Economic Commission for Europe**Inland Transport Committee****World Forum for Harmonization of Vehicle Regulations****Working Party on General Safety Provisions****116th session**

Geneva, 1–5 April 2019

UN Regulation No. 26 (External projection for passenger cars)**Proposal for Supplement 4 to the 03 series of amendments to
UN Regulation No. 26 (External projection for passenger
cars)****Submitted by the expert from France***

Figure 0
Example of parts distribution

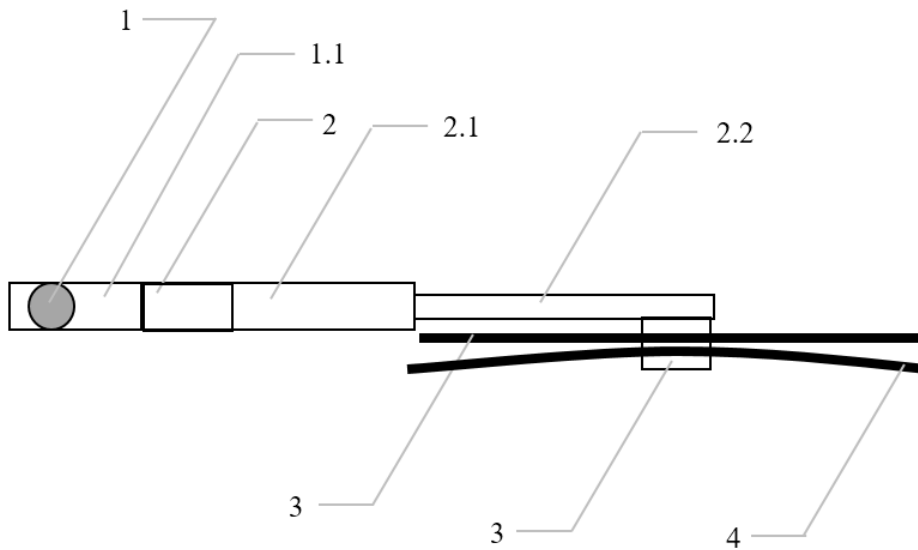
- "6.4. Windscreen wipers
- 6.4.1. The windscreen wiper fittings shall be such that the wiper shaft (**number 1 in Figure 0**) is furnished with a protective casing (**number 1.1 in Figure 0**) which has a radius of curvature meeting the requirements of paragraph 5.4. above and an end surface area of not less than 150 mm². **The holder (head, main and/or other parts, i.e. numbers 2, 2.1 and 2.2 in Figure 0) are designed with a radius of curvature meeting the requirements of paragraph 5.4. above.** In the case of rounded covers, these shall have a minimum projected area of 150 mm² when measured not more than 6.5 mm from the point projecting furthest. These requirements shall also be met by rear window wipers and headlamp wipers.

- 6.4.2. Paragraph 5.4. shall not apply to the wiper blades (**number 4 in Figure 0**), ~~or~~ ~~to any~~ to supporting members (**number 3 in Figure 0**) or to the functional hinge between the holder head and the holder. However, these units shall be so made as to have no sharp angles or pointed or cutting parts.
